# ADDENDUM NO. 3

**August 13, 2026**

Perry Township Schools:
Southport High School Addition & Renovation Phase 2 (Classroom Addition and Athletic Renovations)
971 E. Banta Road
Indianapolis, IN 46227

1 TECHNOLOGY SITE PLAN
1" = 60'-0"

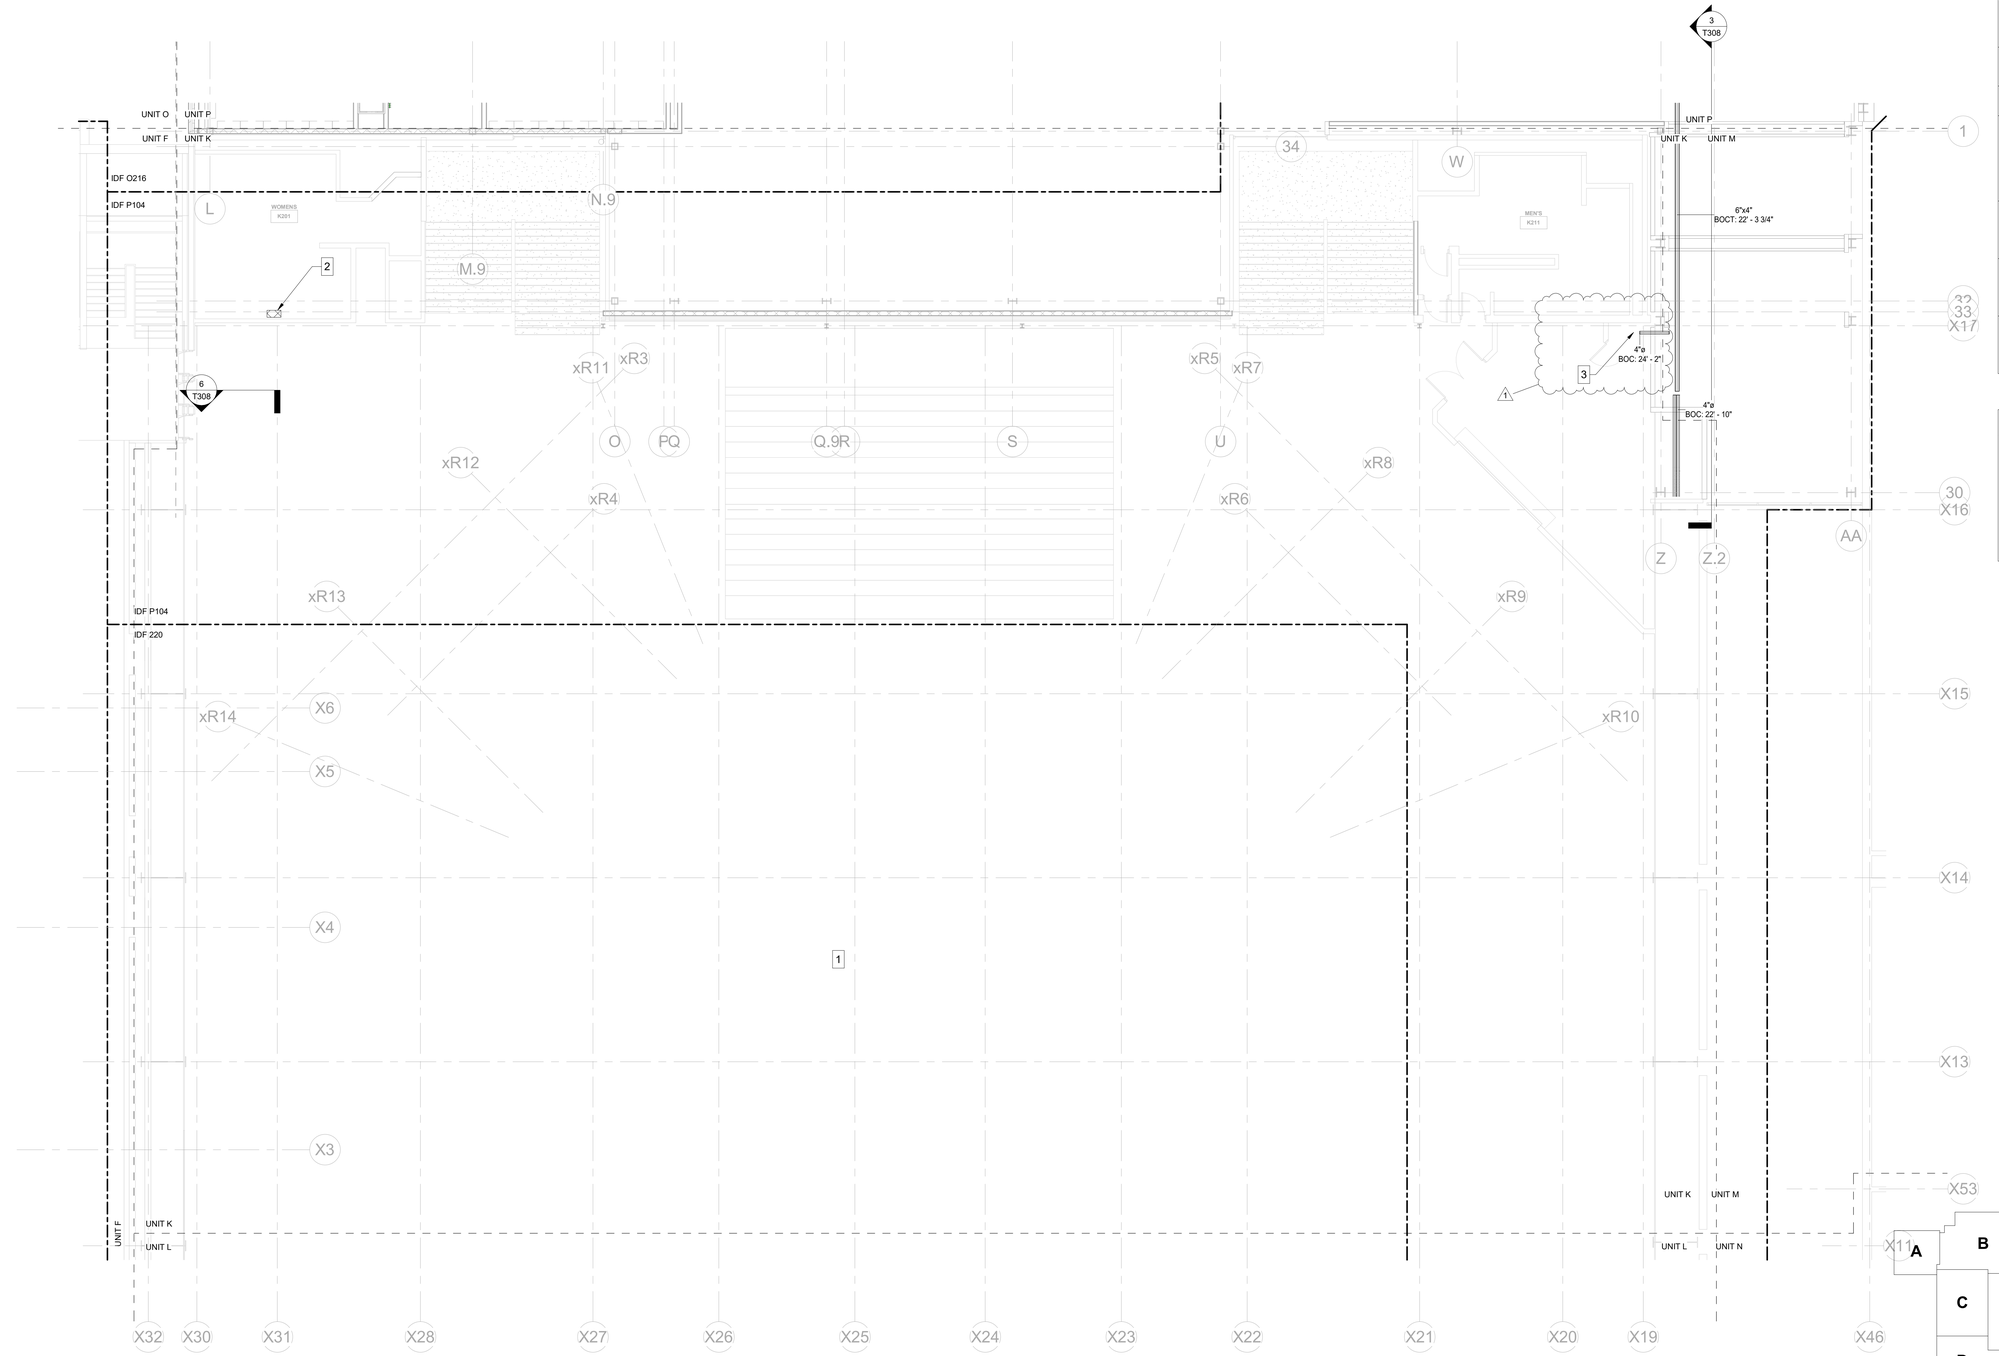
Change: Issued new sheet for site security devices

T102K

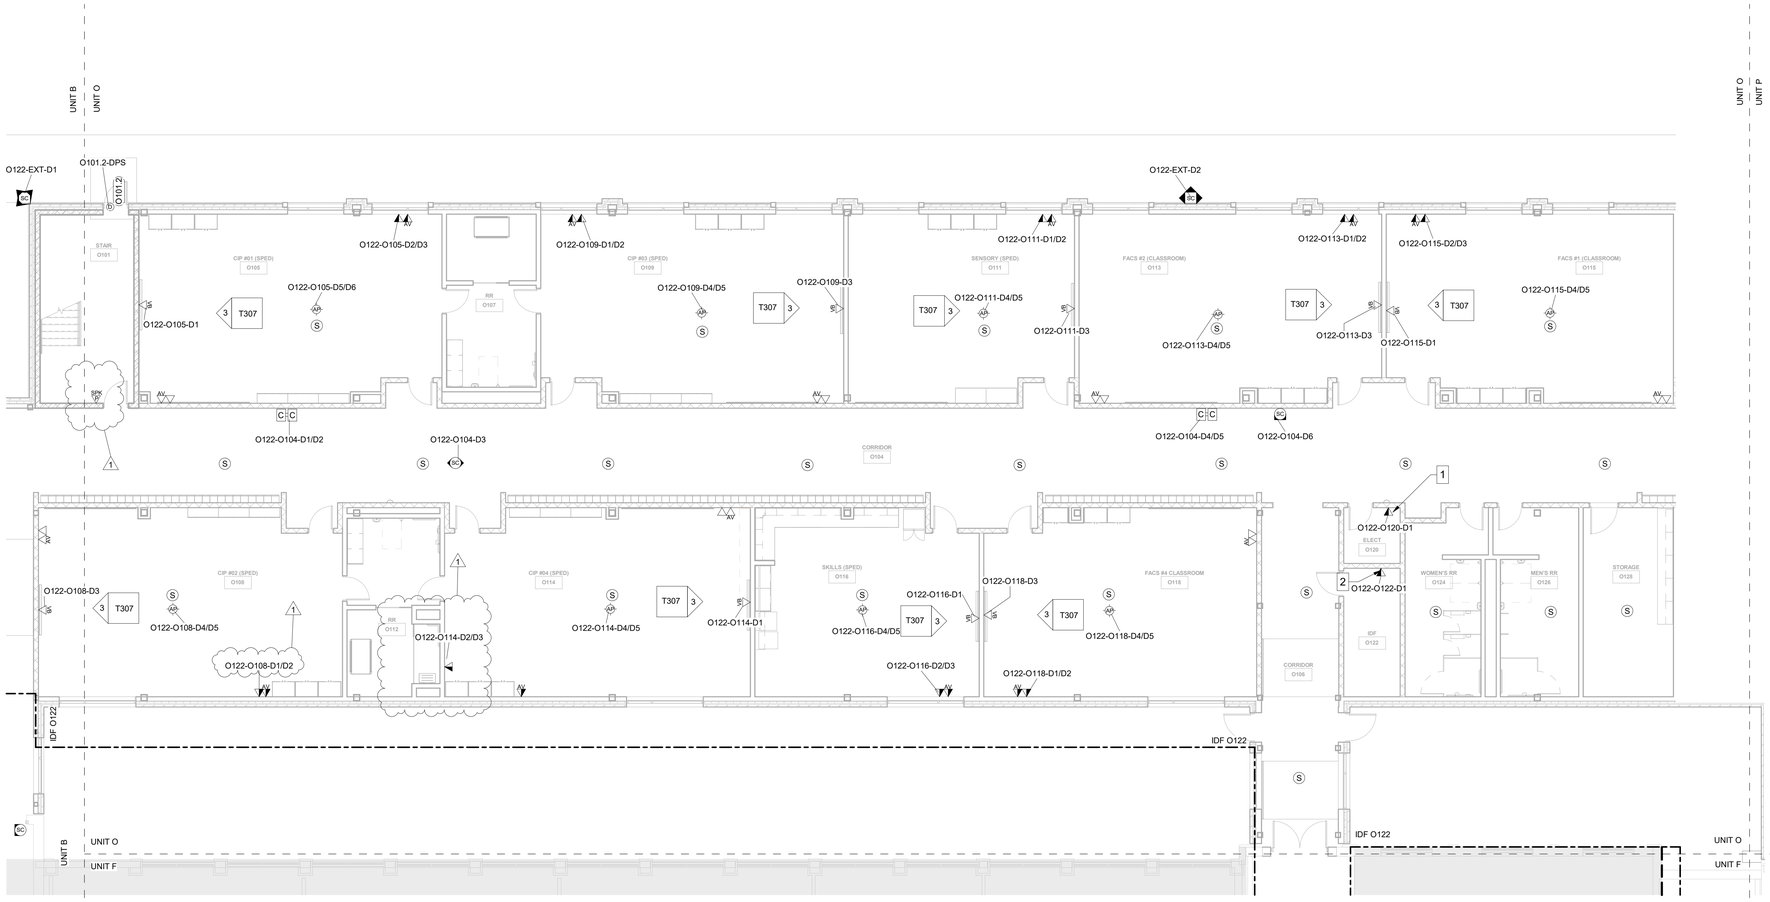
Change: Revised floor plan to reflect actual conditions.

6 SECURITY CAMERA - POLE MOUNTED GREATER THAN 295' FROM IDF
N.T.S.

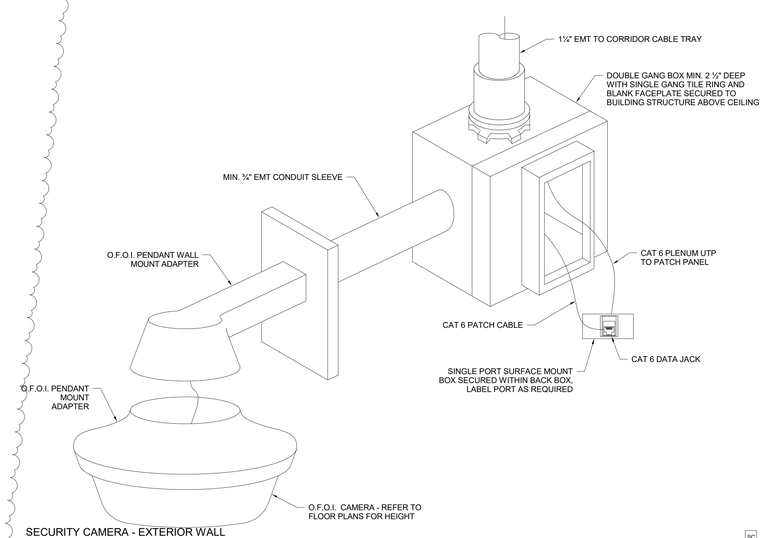
Change: Added site security details
    - Added details #7 and #8
    - Relocated detail #1 on sheet

1 FS2.0 200 FS Spot Location (Layout-P)
1/4" = 1'-0"

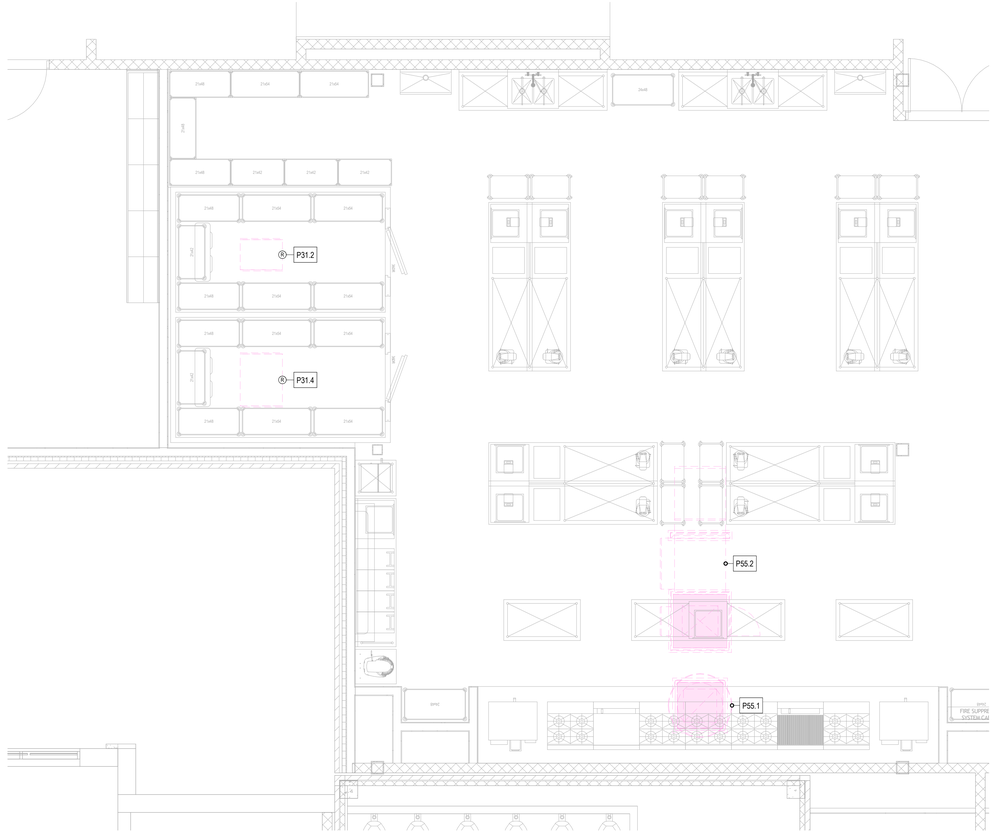
Change:
    - Added and/or revised item 63-73 to the foodservice equipment mechanical schedule.

1 FS2.1 201 FS Spot Location (Layout-E)
1/4" = 1'-0"

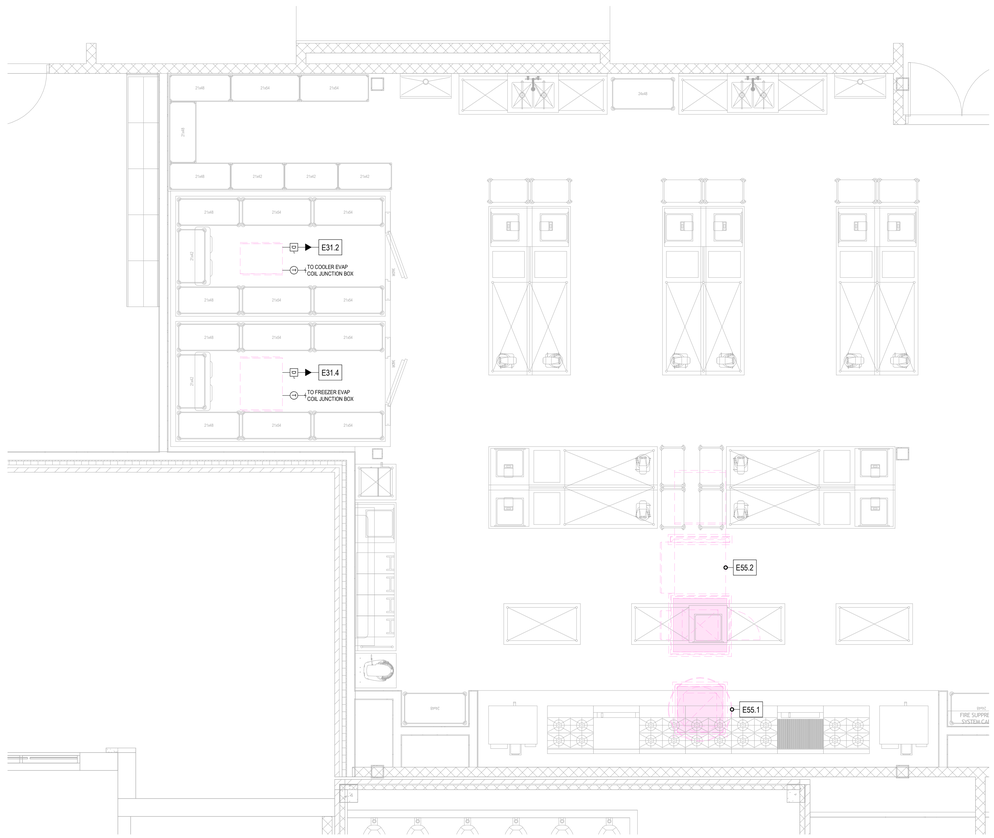
Change:
    - Added and/or revised item 71-83 to the foodservice equipment mechanical schedule.
